UNITED STATES ENVIRONMENTAL PROTECTION AGENCY

Re: Final Comments on November 2012 Draft of the Remedial Investigation Report for Operable Unit 3-Upland Soils: LCP Chemical National Priorities List Site, Brunswick, Glynn County, GA

The purpose of this letter is to notify Honeywell International, Inc. (Honeywell) that the Environmental Protection Agency is hereby disapproving the company's November 2012 draft Remedial Investigation (RI) Report submitted for the Upland soils, designated as Operable Unit (OU3) of the LCP Chemical Superfund Site (Site). Pursuant to Section VIII of the Administrative Order by Consent for Remedial Investigation/Feasibility Study, Docket No. 95-17-C (RI/FS AOC), the EPA is directing Honeywell to cure the few remaining deficiencies, as described below, and resubmit the revised final draft RI for OU3 to the EPA for approval within thirty (30) calendar days of receipt of this letter. Please note that, pursuant to the RI/FS AOC, once the EPA approves or modifies a deliverable or portion thereof, Honeywell may not alter or amend such deliverable or portion unless directed by the EPA to so do.

NORTHWEST AREAS

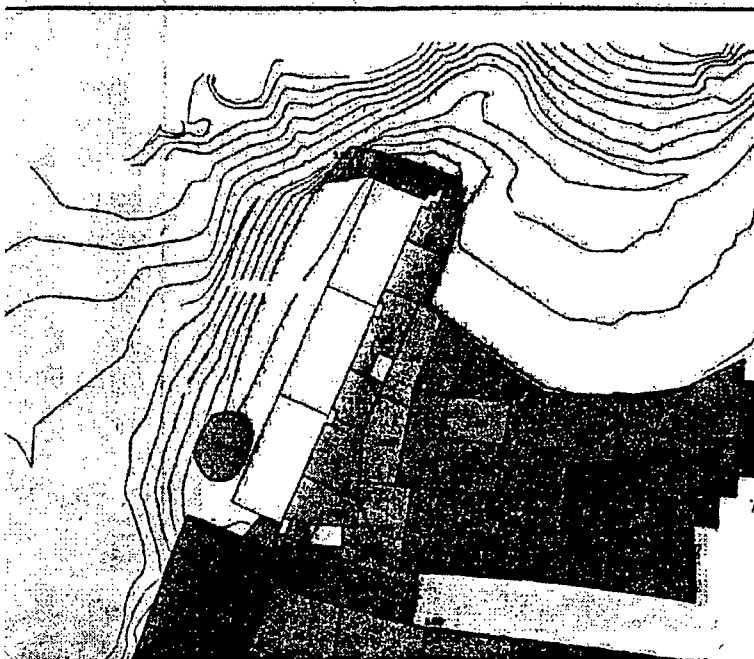
The removal areas shown on the figures obstruct the view of the grids. Please fade-out the removal area color so that the grids may be seen.

Page C-4 of Appendix C discusses the distribution of lead in surface soils of OU3. The uplands were gridded out, and average concentrations within the grids were plotted on the figures. The

text does not mention that the concentrations of lead in soils are above the 400 mg/kg preliminary remediation goal (PRG) for the mourning dove in Grid Cell 133 when the one sample from TEG is eliminated. The three non-TEG samples have lead concentrations of 922, 1580, and 832 mg/kg. Grid Cell 133 is located adjacent to the southern portion of the Dillon Duck and is in a habitat area. Soils on the shore of the Dillon Duck could erode into the pond. Waterfowl accessing the pond from the shores could come into contact with elevated lead in soils and become exposed through incidental ingestion of soils. Lead concentrations in soils are relatively low apart from within Grid Cell 133. The text should mention that the highest average concentration of lead in soils is located in a habitat area.

Note that the figure in the December 1997 North Area Close-Out Report, showing the removed characterization/confirmational sampling locations, does not show the three samples located in Grid Cell 113 referred to above. The characterization samples table in the report does list the three samples. The field note on the August 30, 1996 chain-of-custody form describes the three samples as having been collected along the "edge of marsh along east side of N(orth) S(eparator)." Further, the as constructed excavation figure included in the Close-Out Report (reproduced in part below) shows the area immediately east of the North Separator having been removed and backfilled. It is unclear whether the area represented by these three samples was removed. This requires further investigation.
